**Subject: Docket Nos. 50-361 and 50-362
Response to Request for Additional Information Regarding Use of
American Concrete Institute (ACI) Reports for Restoration of Unit 3
Containment (TAC Nos. ME6179 and ME6180)
San Onofre Nuclear Generating Station, Units 2 and 3**

Response to Request for Additional Information Regarding Use of American Concrete Institute (ACI) Reports for Restoration of Unit 3 Containment

Fig. 1 Relationship between concrete strain and effective stiffness: Vertical direction

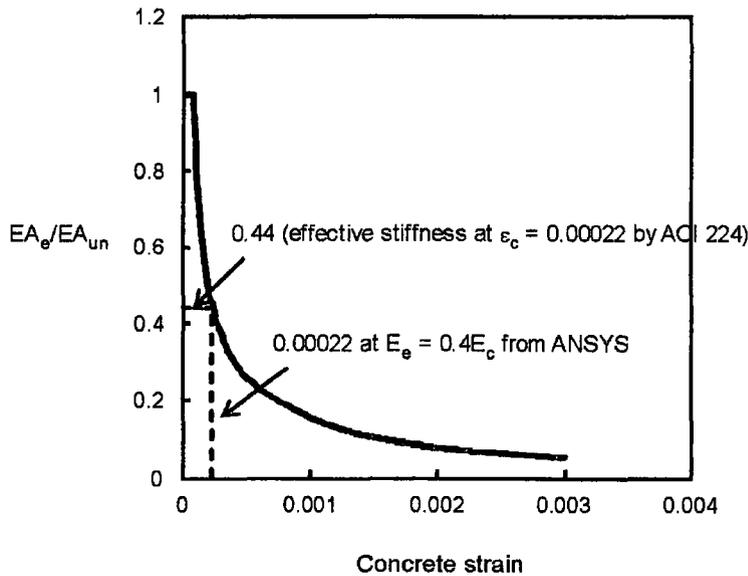
- (d) Please provide a numerical example of all steps (with all inputs used) of a typical calculation (e.g., for the ratio, $(E_c A_e)_{ANSYS}/E_c A_g = 0.4$ or 0.6) that was performed to develop a data point (one in hoop direction and one in vertical direction) in Figure H.2 of Reference 2.

By repeating the calculation for different axial loads, P , the relationship between the concrete strain and the corresponding effective stiffness can be obtained. The following figure shows the resulting relationship.

From Figures 1 and 2, the ratio of effective stiffness in ACI 224.2R to that of ANSYS can be calculated as follows:

$$\text{Vertical direction: } (E_c)_{ACI224}/(E_c)_{ANSYS} = 0.44/0.40 = 1.10$$
